ADDENDUM NO. 1

ISSUE DATE: September 7, 2023

PROJECT: City of Slaton
Senior Citizen Center

1 FLOOR PLAN - LIGHTING

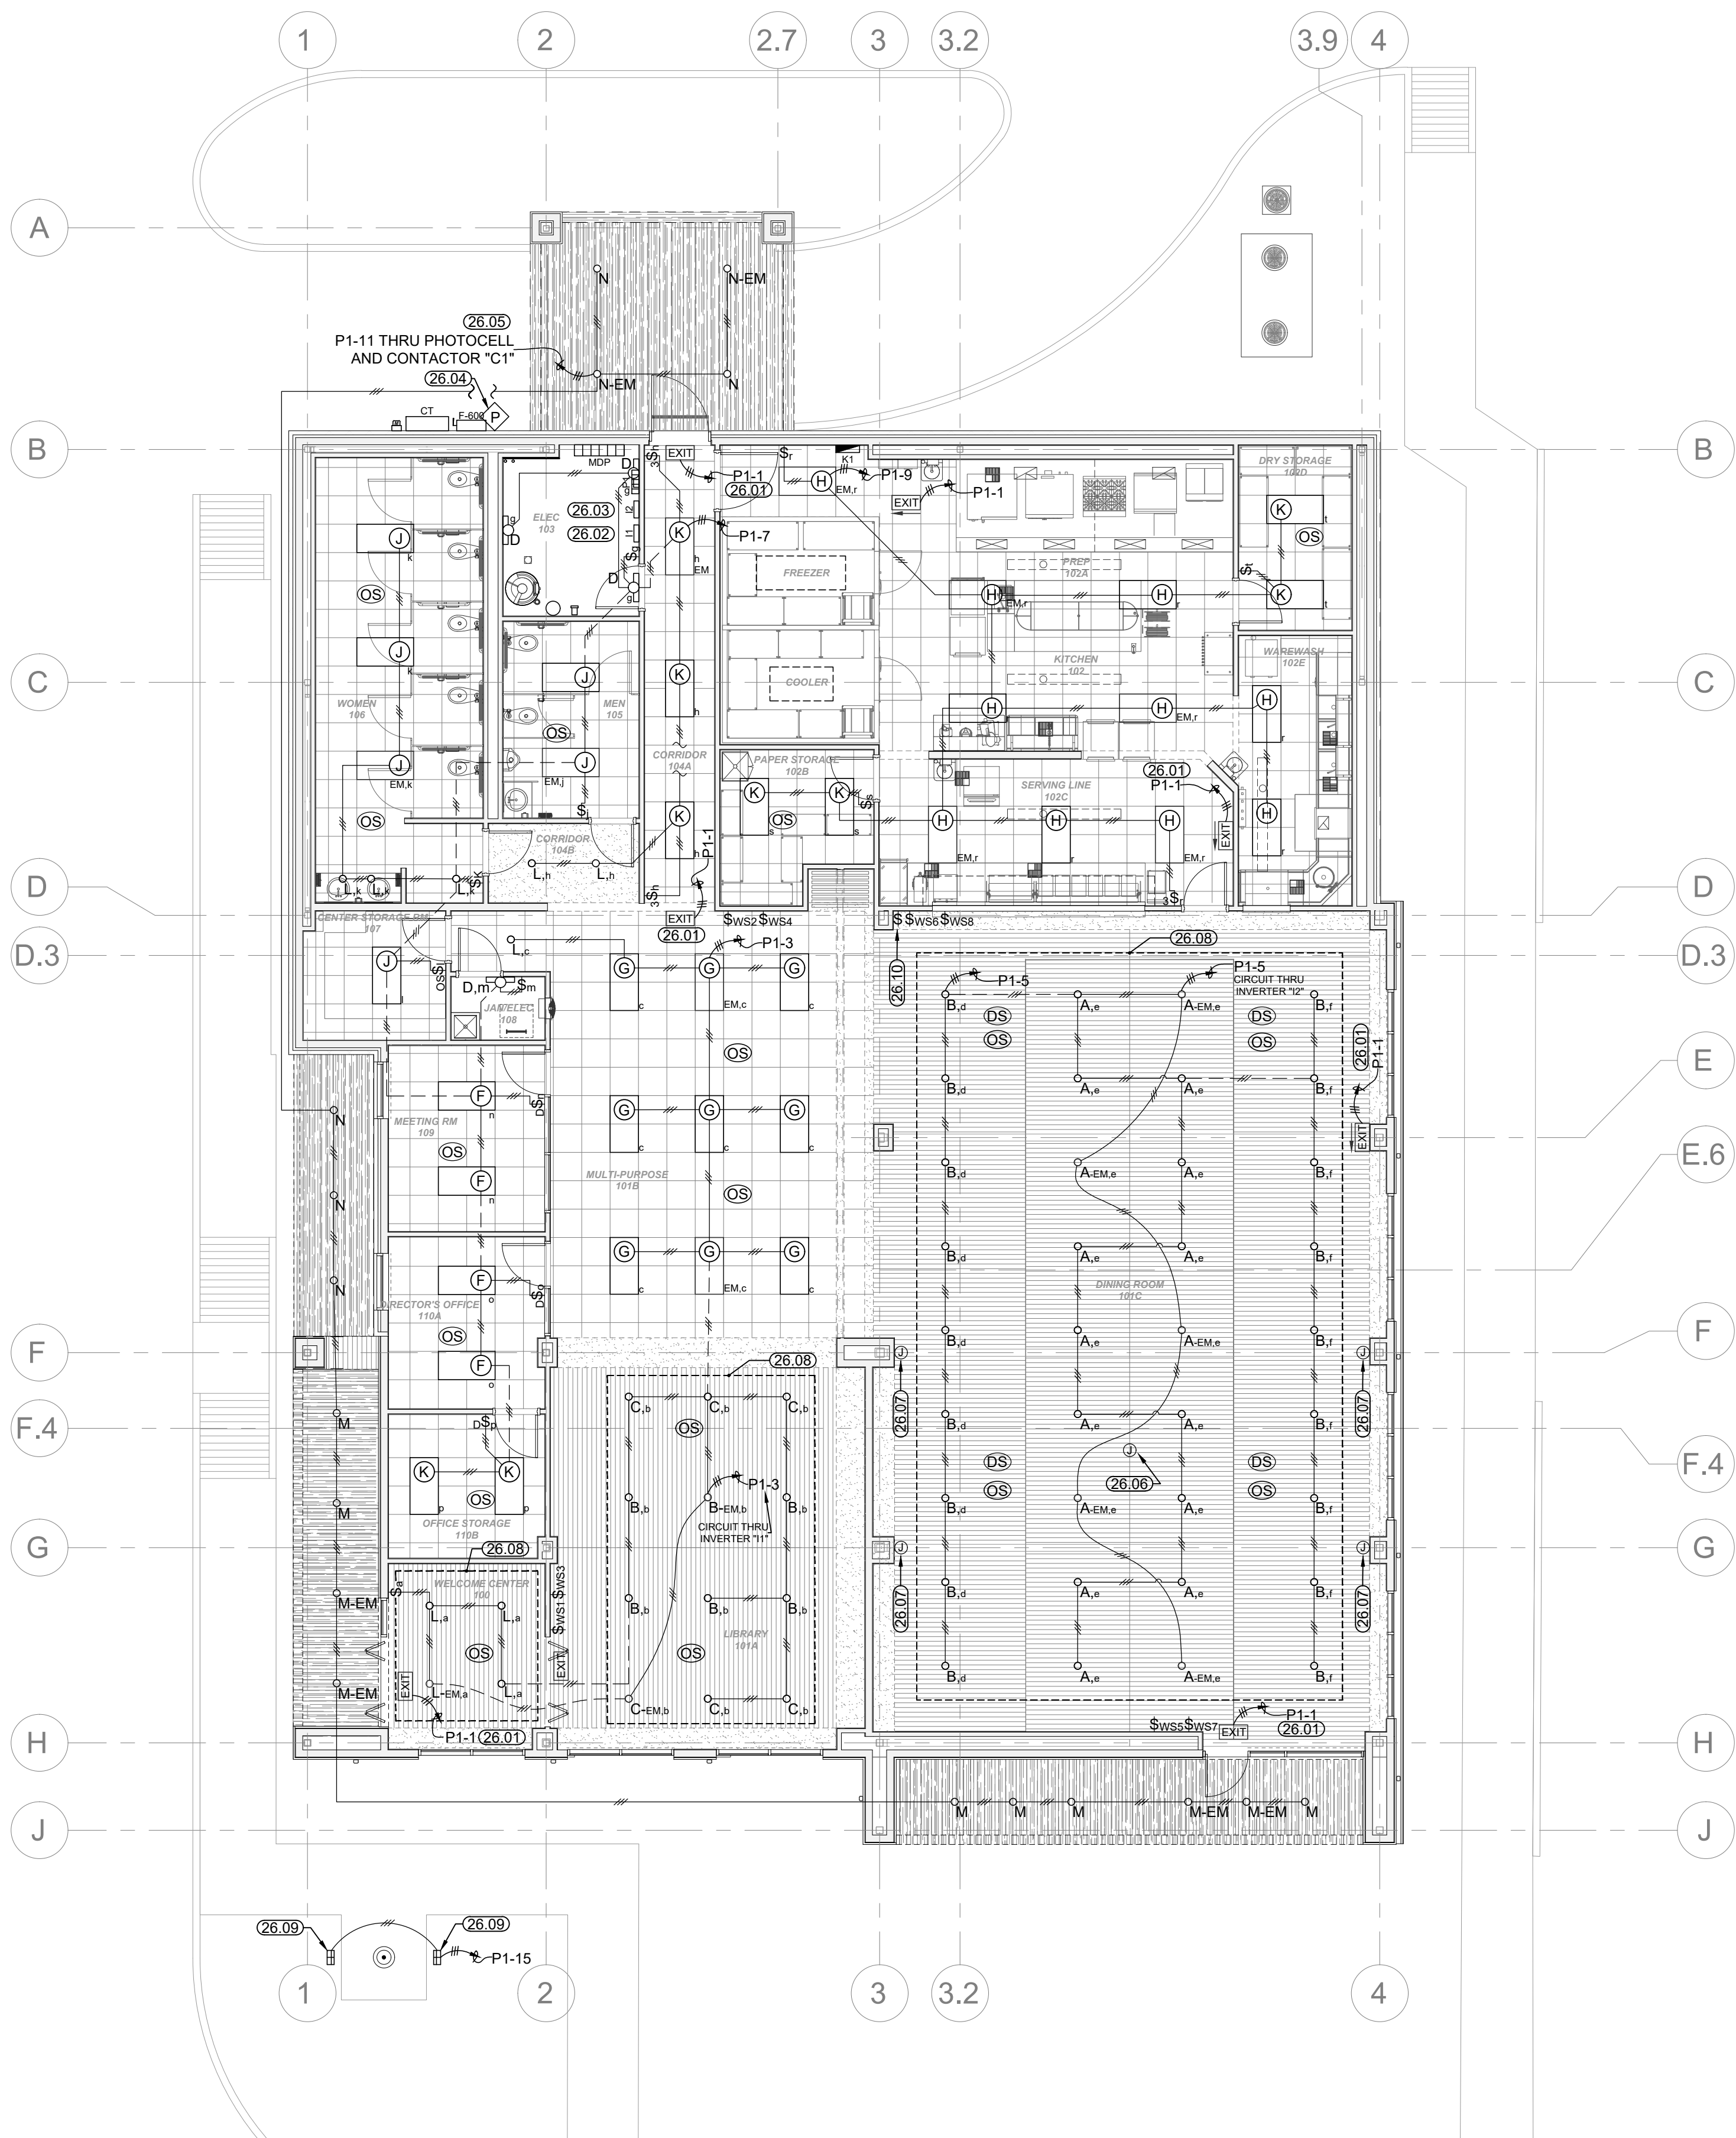
- Item #D8** **Sheet E2.0** – Replace sheet with attached E2.0 dated 09-07-2023. Additional information regarding the disco ball operation and monopoint led for disco ball illumination.

- Item #Q6** **Question:** On sheet E2.0 note 26.06 calls for a disco ball motor. Does the disco ball also need to be provided, if so, what size is needed?

- Answer:** Yes, a disco ball is required. The disco ball information is provided on sheet A7.0 in keyed note #8.

(26.06) DISCO BALL MOTOR, XSTATIC X-MBM3. PROVIDE SINGLE OUTLET MOUNTED TO BOTTOM OF BEAM AT RIDGE OF ROOF. CONFIRM REQUIREMENTS WITH OWNER. VERIFY HEIGHT WITH OWNER AND ARCHITECT PRIOR TO INSTALLATION.

(26.07) PROVIDE LED MONOPONT LUMINAIRE EQUAL TO WAC SILO X10 MODEL M0-2010-930-WT. COORDINATE ADDITIONAL REQUIREMENTS WITH FIXTURE FURNISHED. POWER FIXTURE FROM CIRCUIT P1-35 WHICH ALSO POWERS DISCO BALL. REFER E1.0 POWER SHEET. DISCO BALL AND PIN SPOTS TO BE ENERGIZED THRU LIGHT SWITCH LOCATED ADJACENT TO ROOM LIGHT SWITCHES. VERIFY MOUNTING HEIGHTS WITH OWNER AND ARCHITECT PRIOR TO INSTALLATION.
